ADDENDUM NO. 4:

RE: Town of Canton - Armory Community Center Renovation
71 Penland Street, Canton, NC 28716
CGD|PBK Project No. 23029

1 UPPER LEVEL REFLECTED CEILING PLAN
A802 / 3/16" = 1'-0"

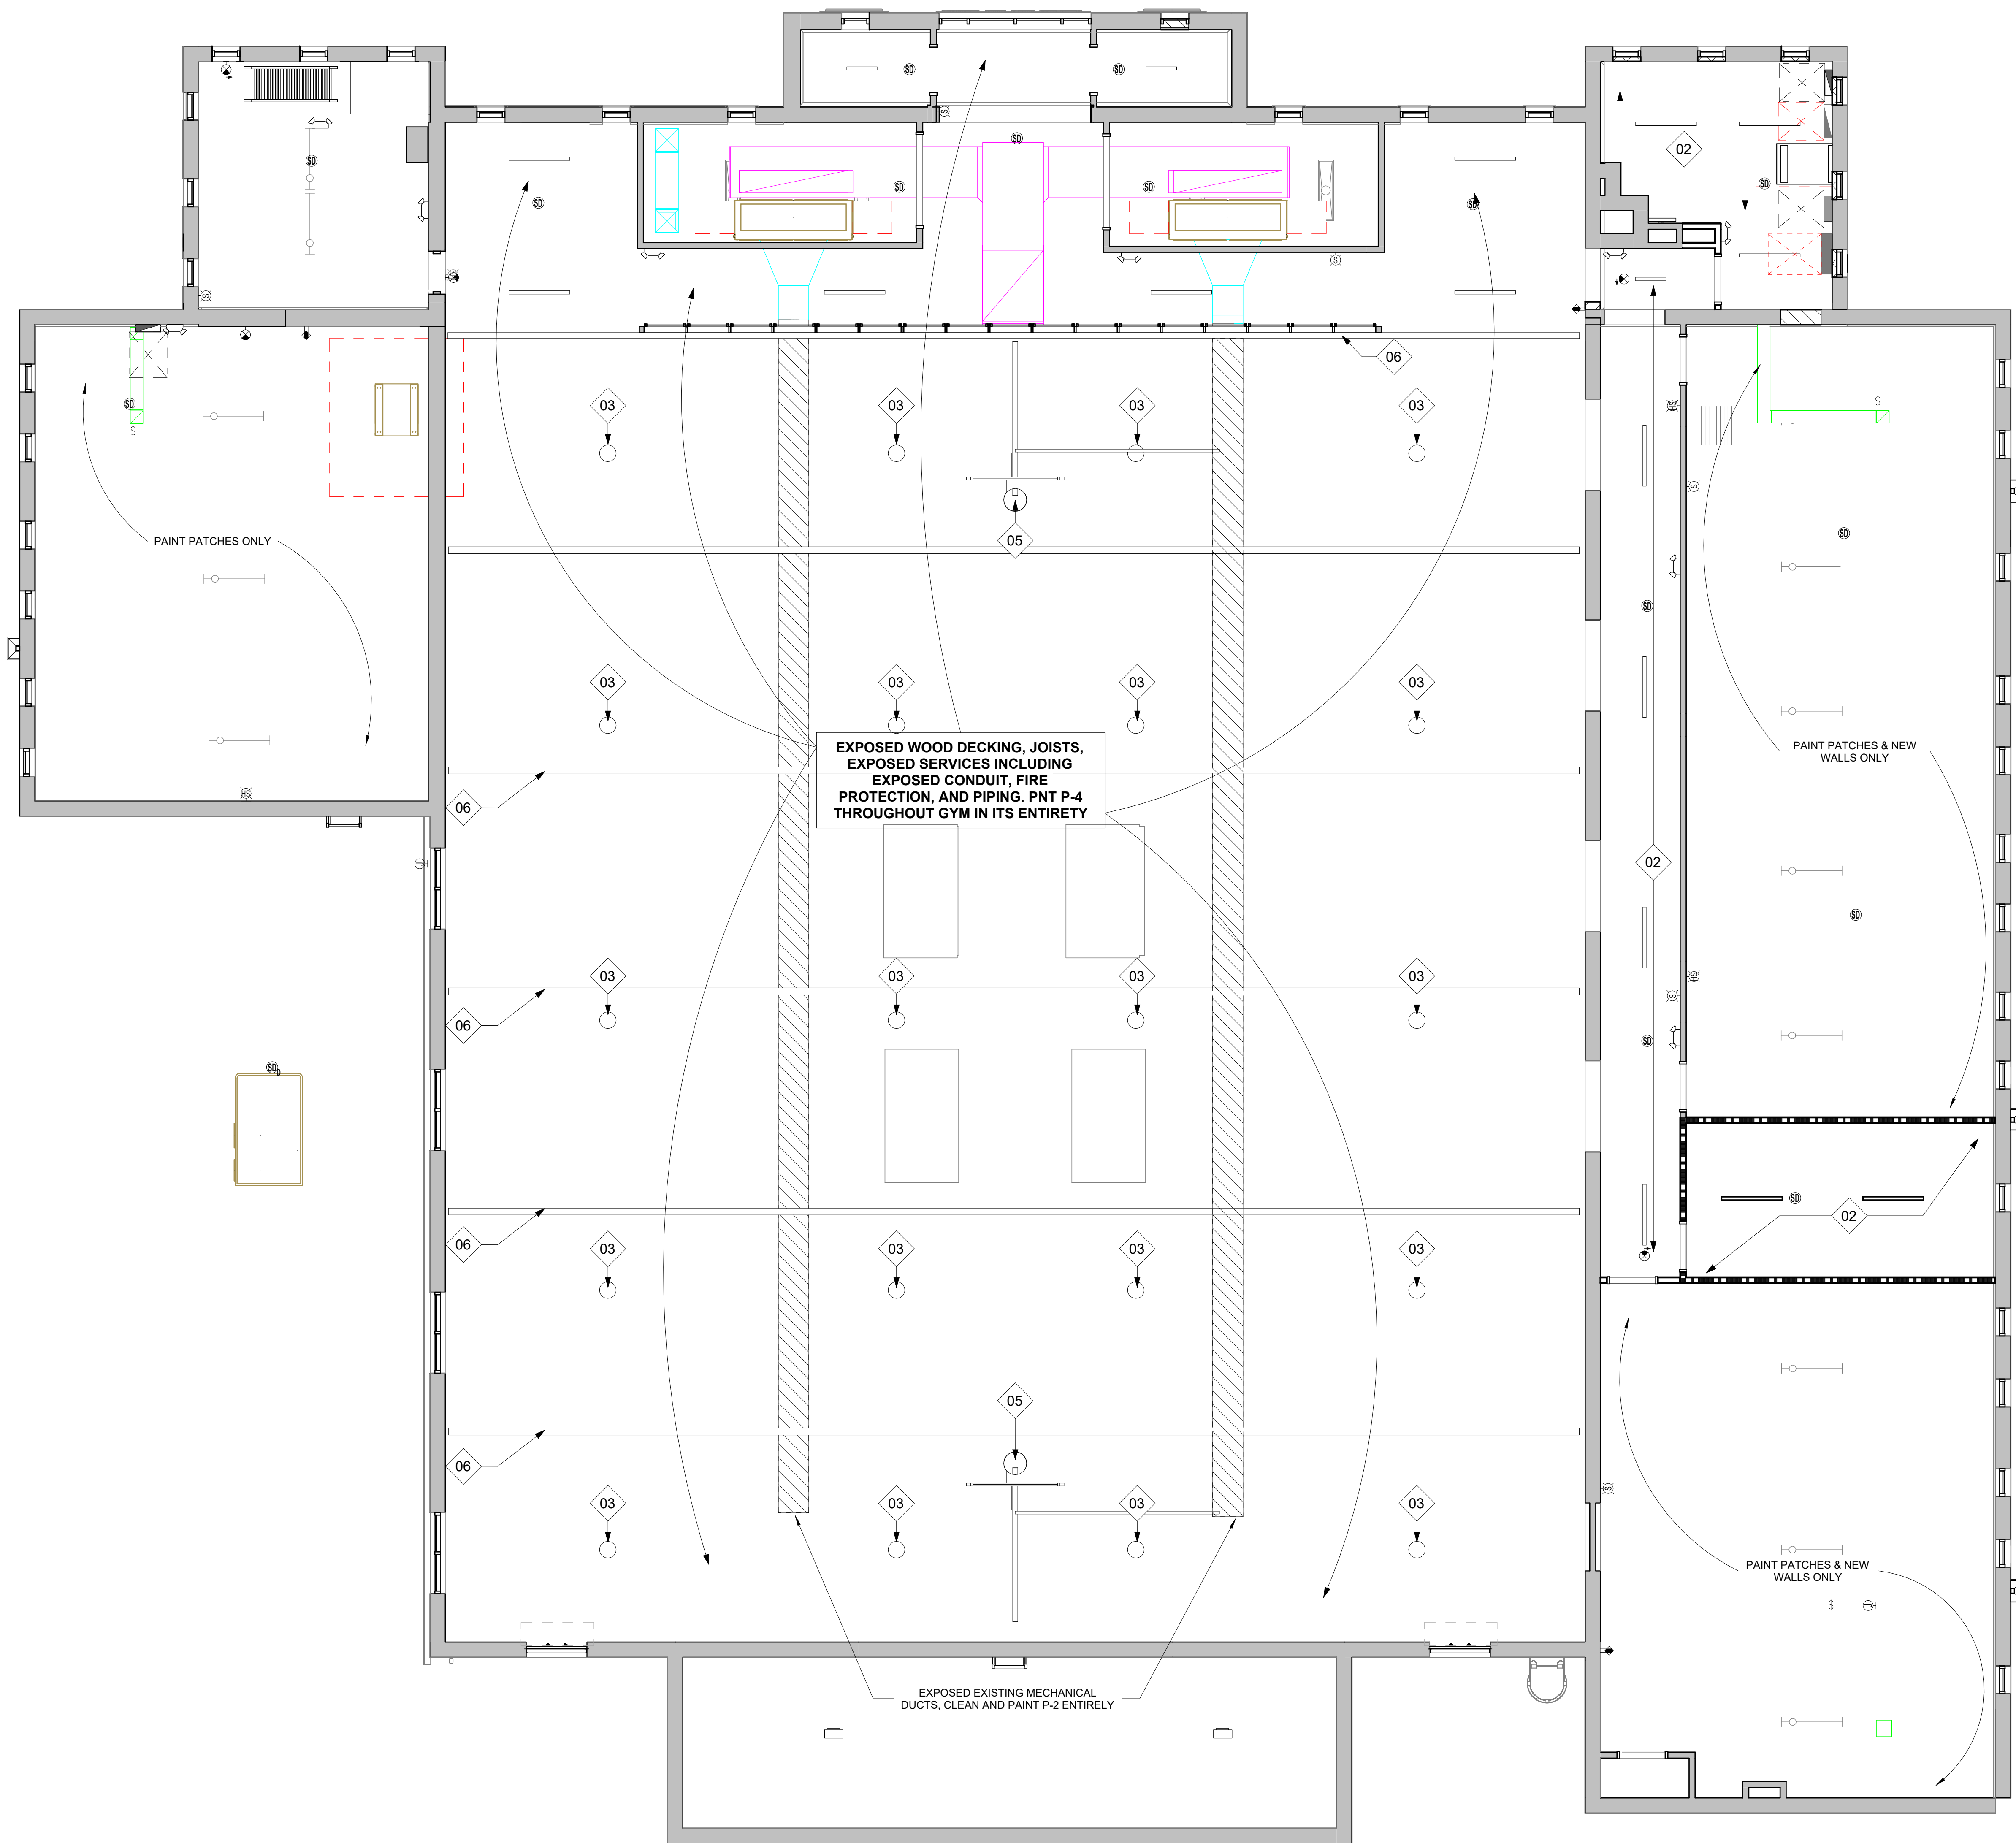
A4-D4 **Drawing A802, UPPER LEVEL REFLECTED CEILING PLAN:**

REVISE: Keynote Legend. Keynote #1 is no longer used. Keynote #4 was revised to coordinate with the roof plan. Revise RCP Legend, item ACP-1.

FOUNDATION PLAN

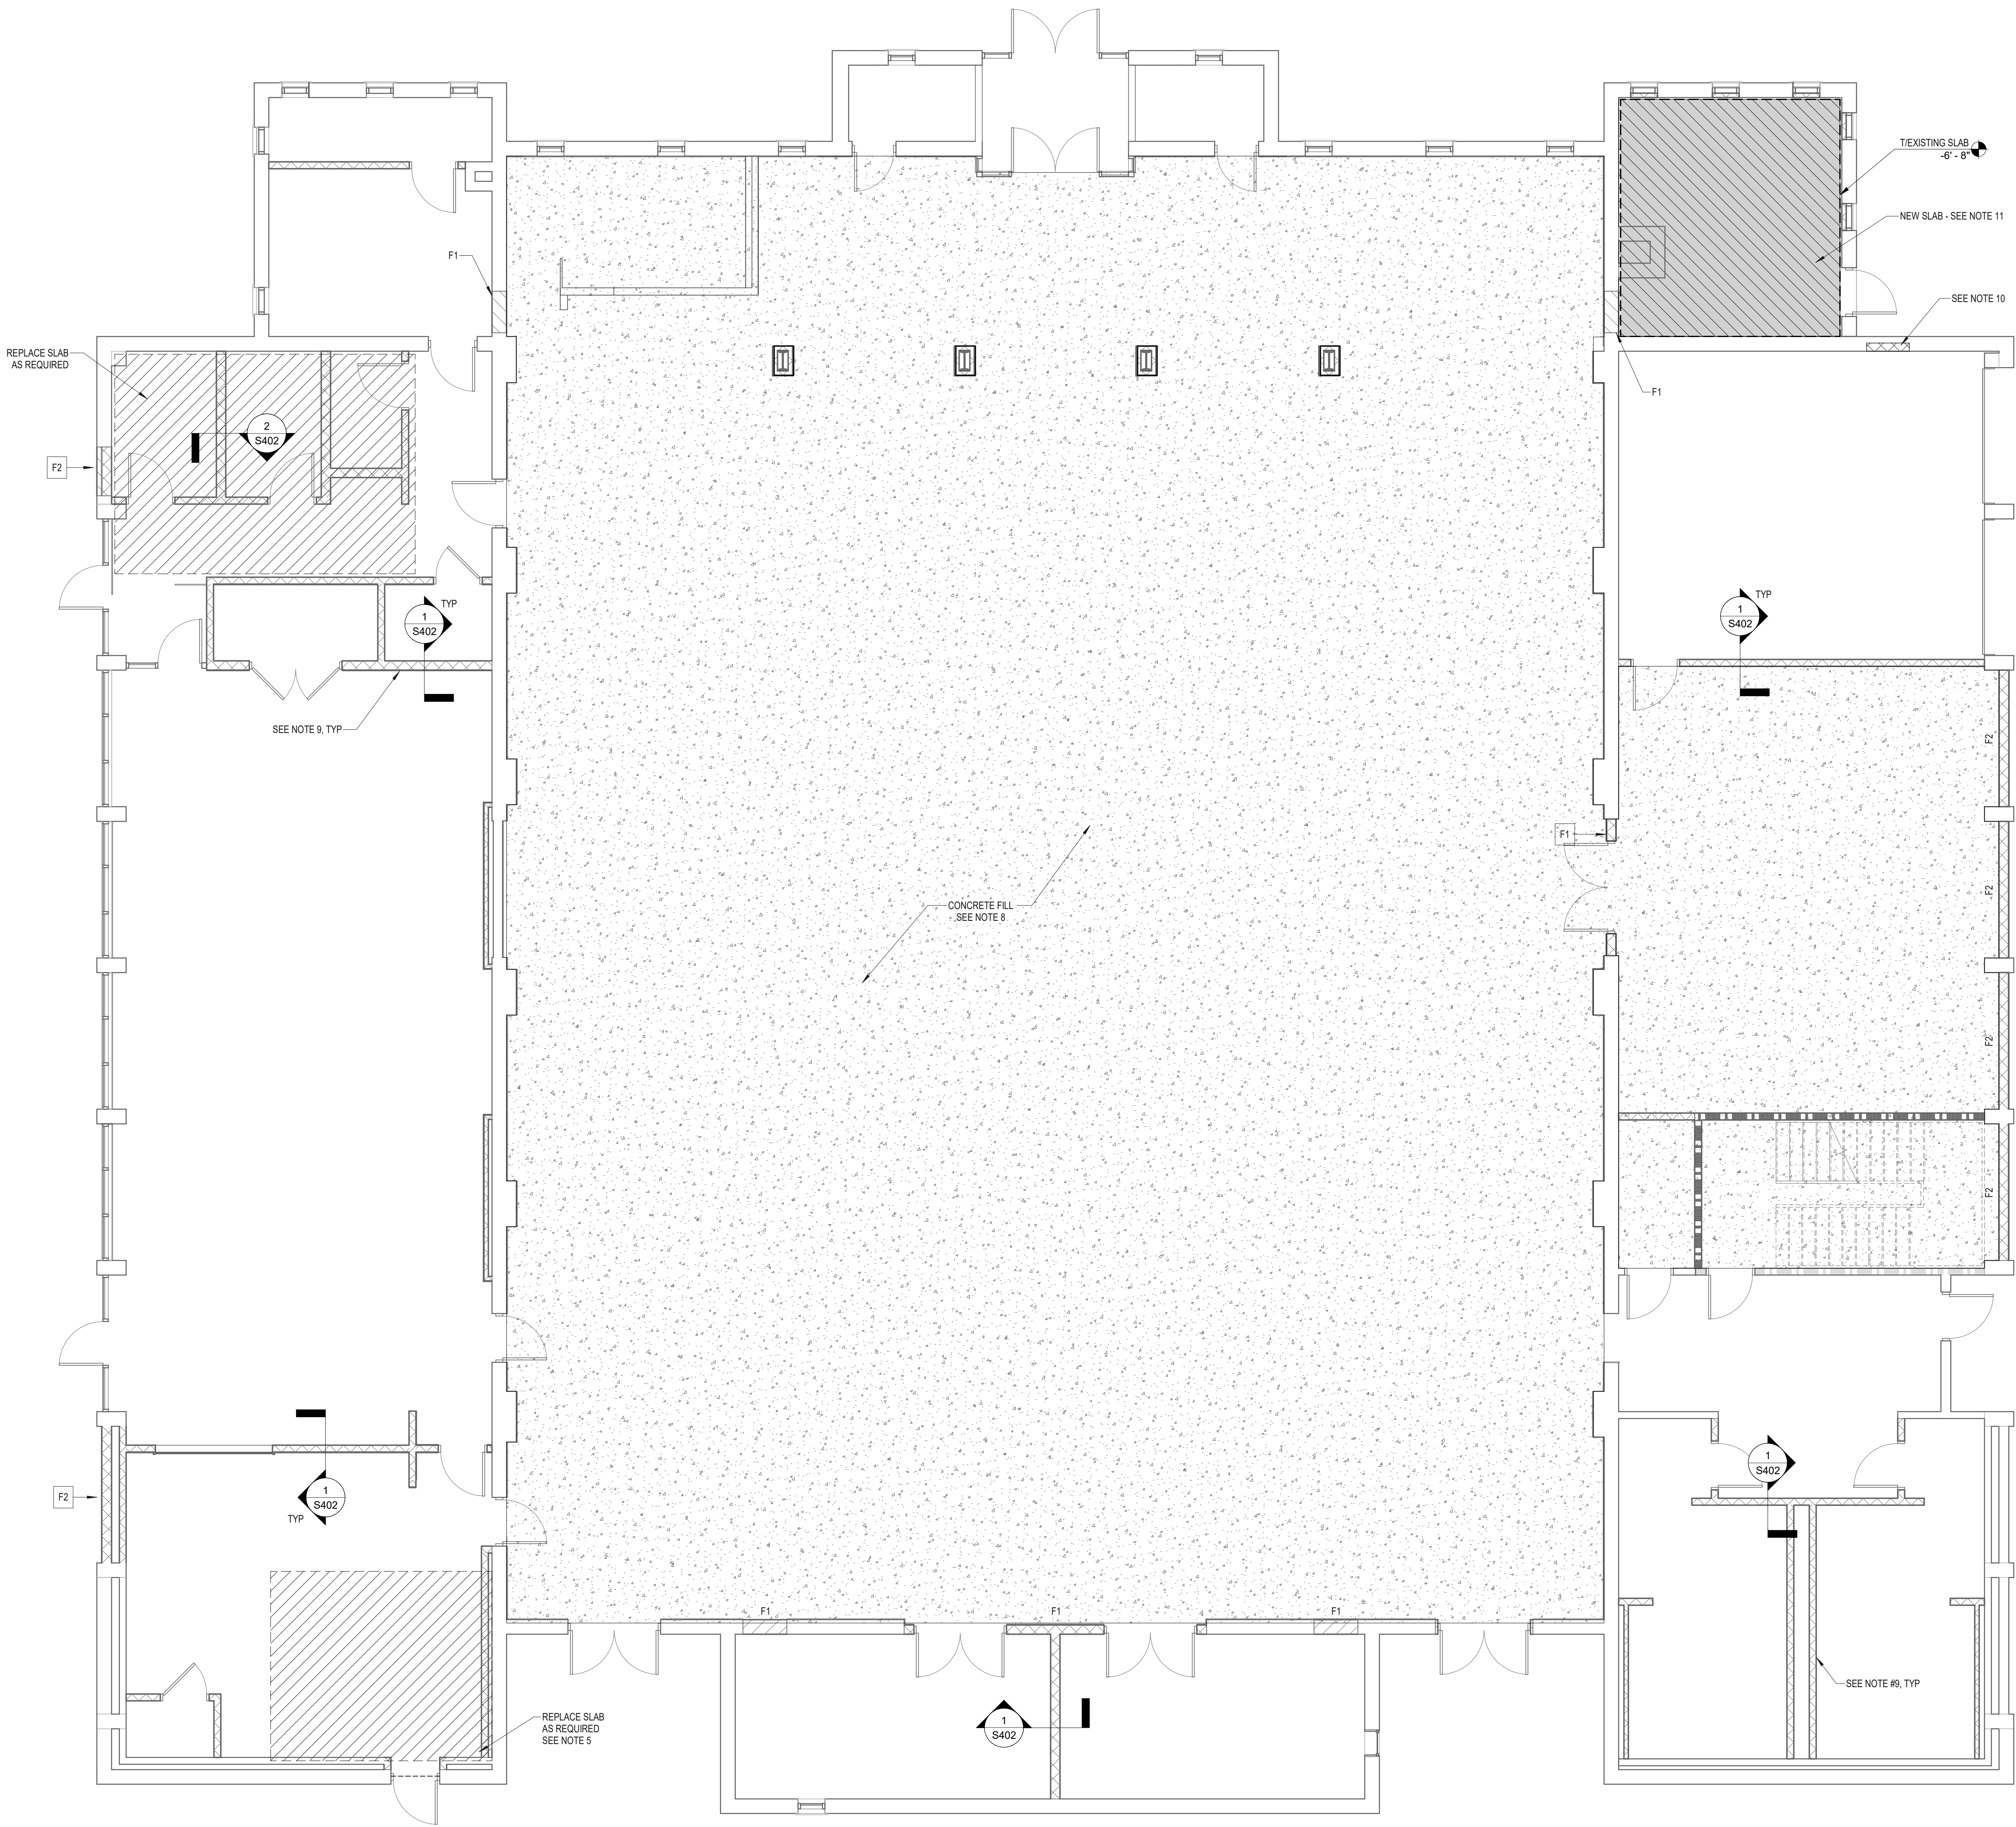
Question: The slab shows wire in the overlay, is fiber reinforcing allowed?

A4-D5 **Drawing S101, FOUNDATION PLAN:**

REVISE: Foundation Plan Note #8.

Answer: Fiber mesh is an acceptable alternate for the WWF.

1 SECOND FLOOR AND LOW ROOF FRAMING PLAN
3/16\" = 1'-0\"

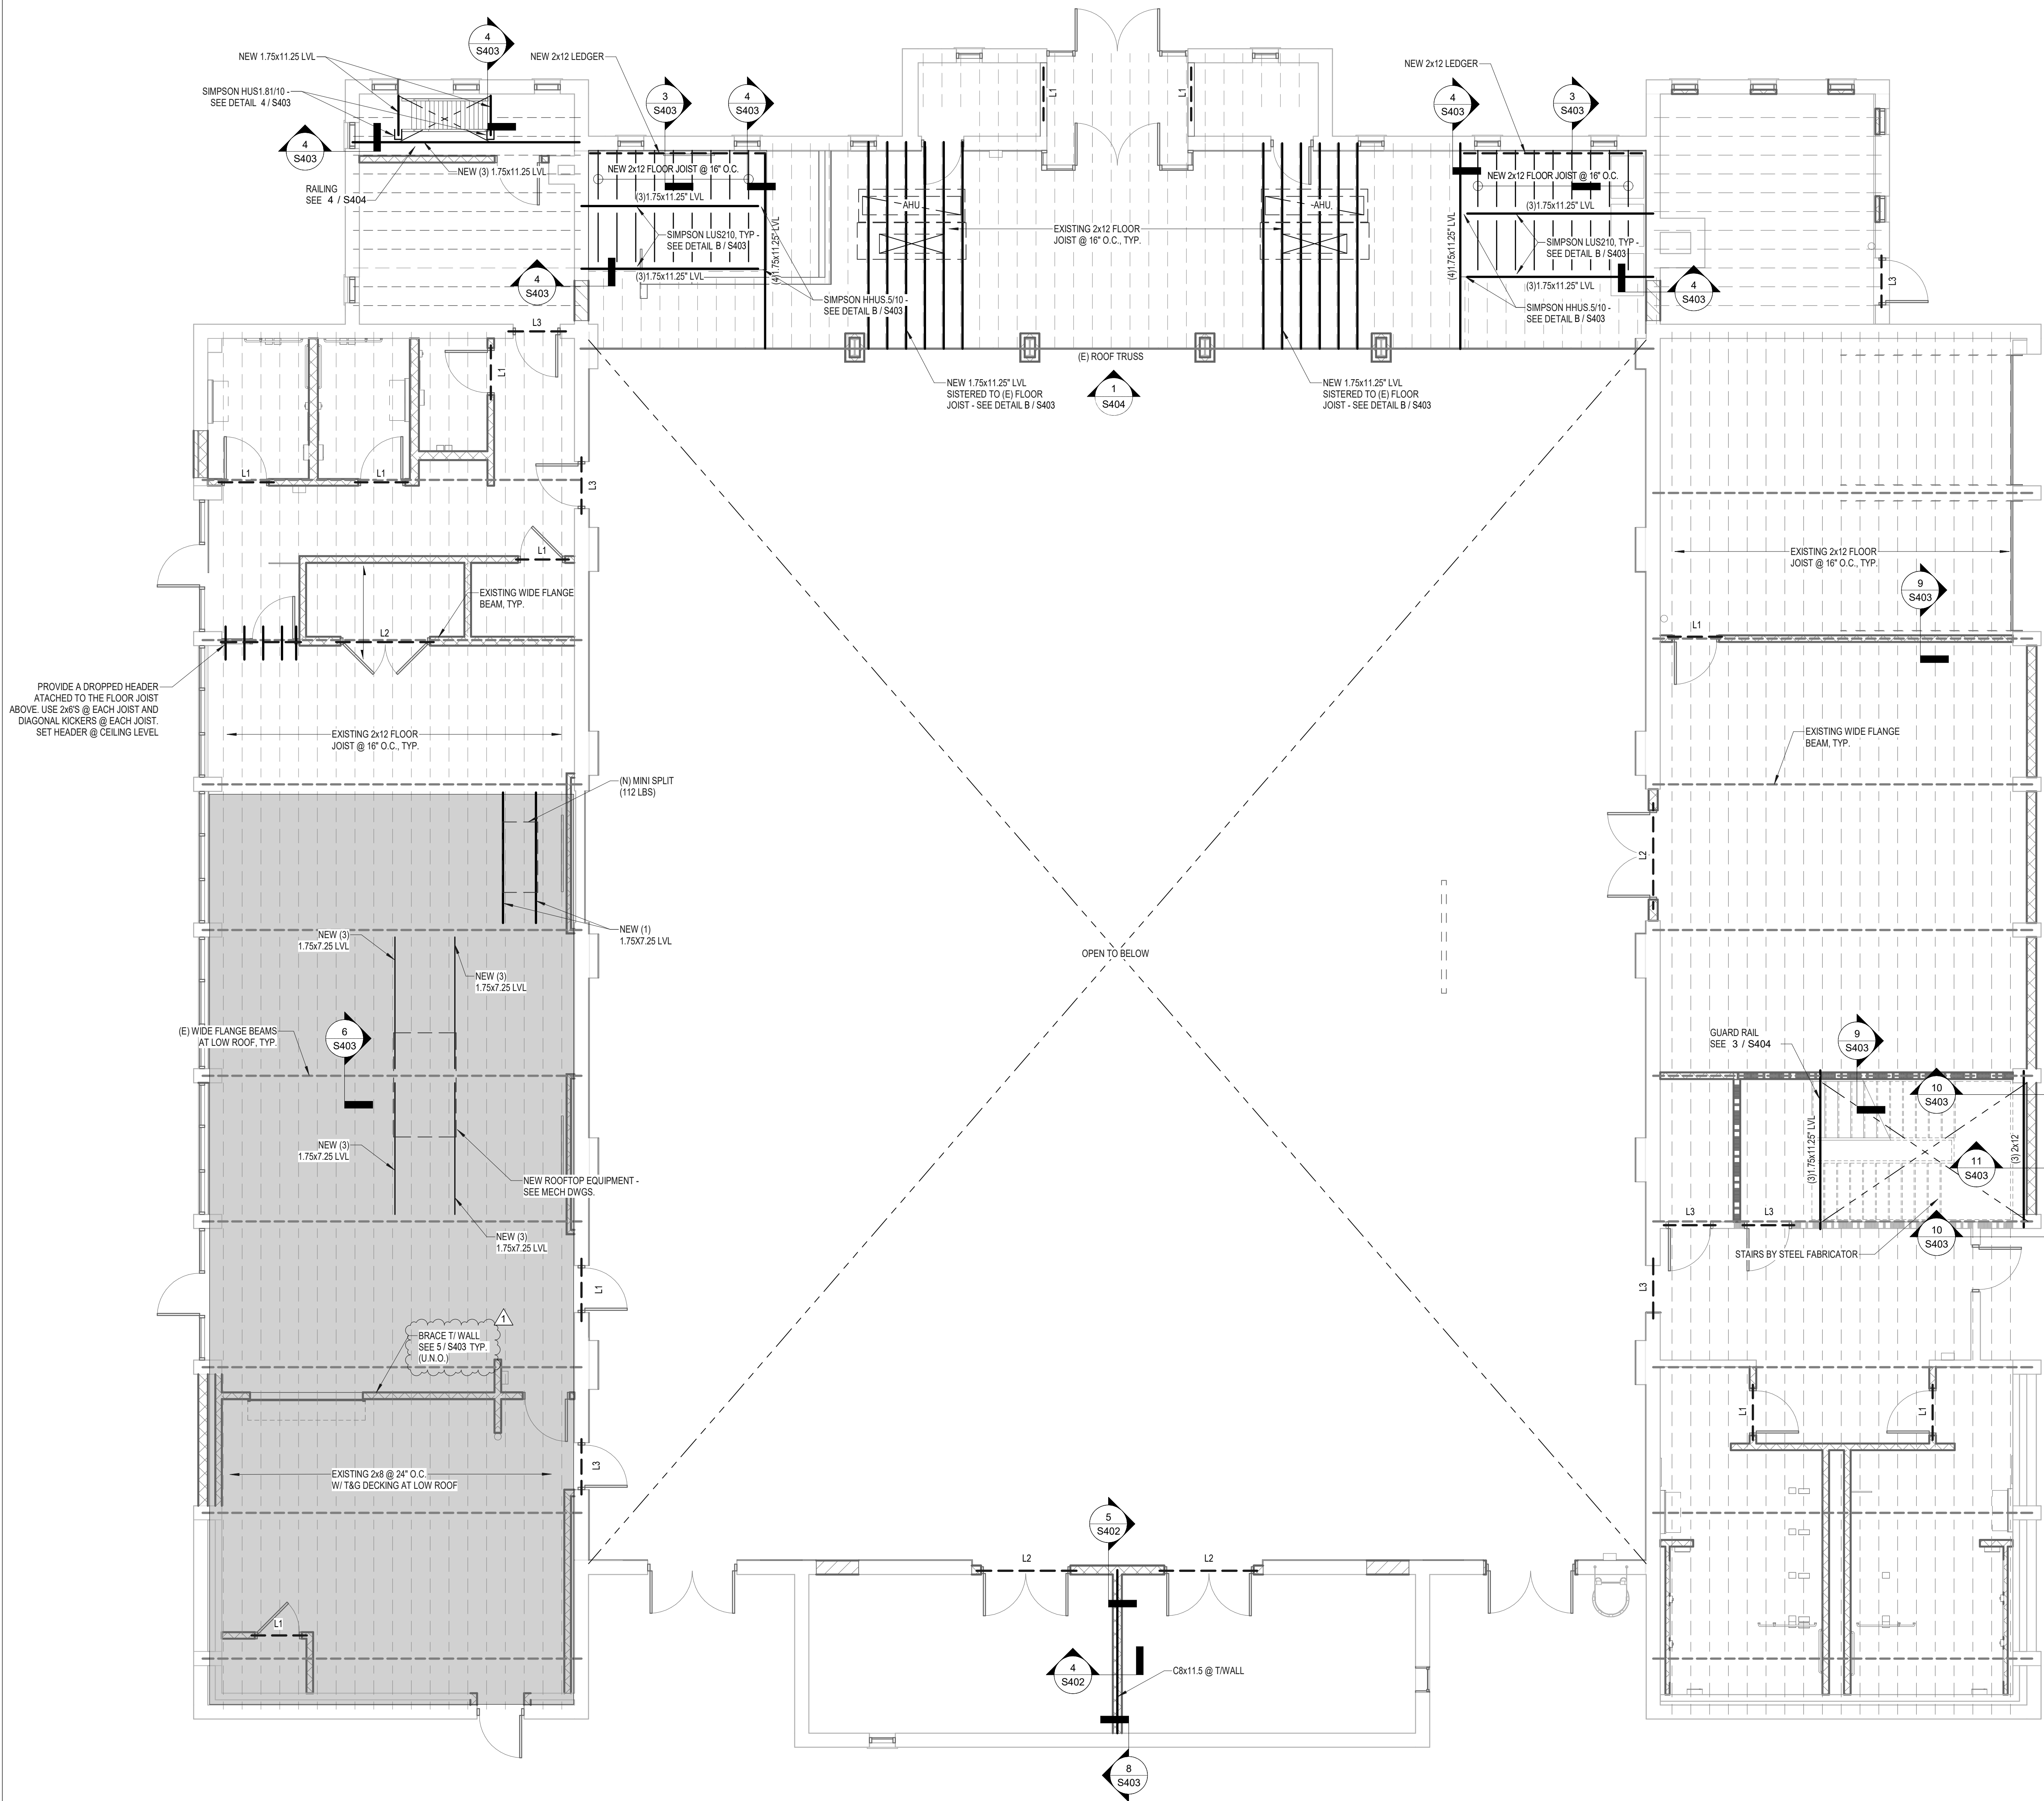
A4-D6 **Drawing S201, SECOND FLOOR AND LOW ROOF FRAMING PLAN:**
REVISE: Note on plan referencing bracing at top of wall (located at south end of room 112 Multi-purpose Room).
